November 23, 2005

Subject: Response to Correspondence

HPI Rio Dell Shell; 481 Wildwood Avenue, Rio Dell, California

LOP No. 12261

MTBE ISOCONCENTRATION MAP

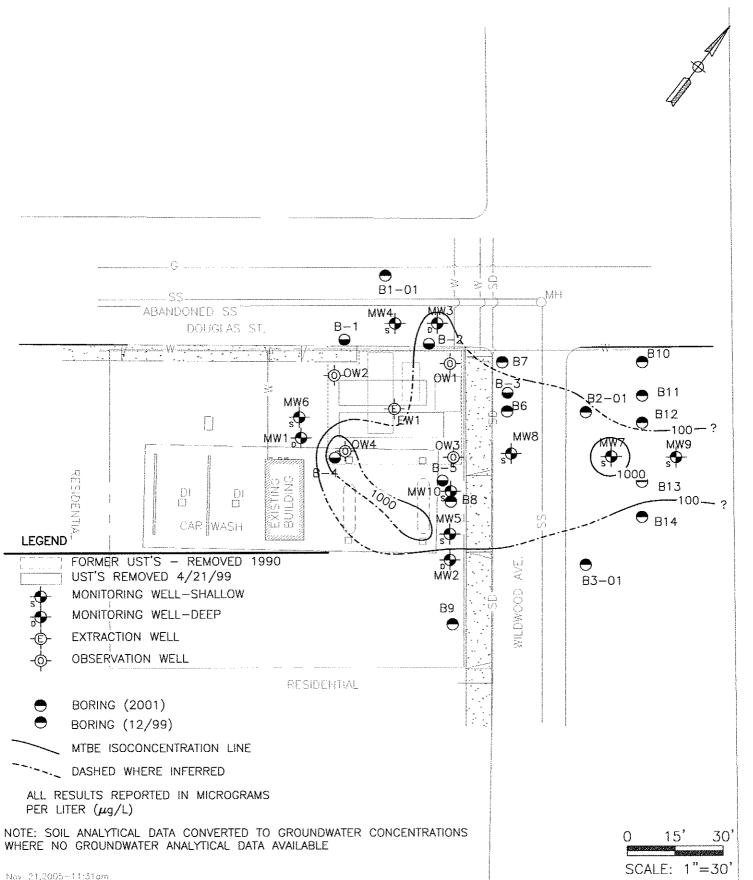
In Figure 4, the northeast edge of the estimated plume is drawn with a solid line, indicating a high level of confidence. It is unclear to us what information is being used to support this interpretation. As mentioned in previous correspondences, no water samples were collected from boring numbers B6 to B14. Additionally, we did not find analytical results from B11 in the recent report.

Figure 4 illustrates dissolved-phase MTBE isoconcentrations. The Figure 4 submitted with LACO's RAP did not include a statement indicating that isoconcentration lines represented laboratory analytical results in micrograms per liter ($\mu g/L$). Please find a corrected Figure 4 included with this correspondence.

Regarding the solid line on the northeast edge of the estimated plume, we recognize that groundwater samples were not collected during the installation of borings in this vicinity. The solid line representing the estimated dissolved-phase MTBE isoconcentrations in this area were based on quarterly groundwater laboratory analytical results of monitoring wells MW7 and MW9, as well as a conversion from sorbed-phase laboratory analytical results to

dissolved-phase laboratory analytical results. Text at the bottom of Figure 4 reads:

'Note: Soil analytical data converted to groundwater concentrations where no groundwater analytical data available'.

Sorbed-phase laboratory analytical results were converted to dissolved-phase laboratory analytical results using the following approximation:

*Groundwater analytical approximation = soil analytical results * porosity * 1,000*

- groundwater analytical approximation are in units of μg/L, or parts per billion
- soil analytical results are in units of micrograms per gram ($\mu g/g$), or parts per million
- porosity (unitless) is the approximate porosity of the lean clay with silt unit reported for the 8- to 12-foot intervals in borings B7 and B11. The American Petroleum Institute indicates a porosity approximation for clayey silt as 0.40 (API, 2004).

LACO approximations of groundwater laboratory analytical results using this conversion are detailed below in Table D. Additionally, monitoring wells MW7 and MW9 have reported maximum dissolved-phase MTBE concentrations of 1,300 μ g/L and 460 μ g/L, respectively, and these maximum values were used to conservatively represent LACO's interpretation of the estimated dissolved-phase MTBE isoconcentrations in this area. LACO has resubmitted Figure 4 with this correspondence, and has updated the isoconcentration lines in the northeast edge of the estimated dissolved-phase MTBE plume to reflect the approximated nature of the data.
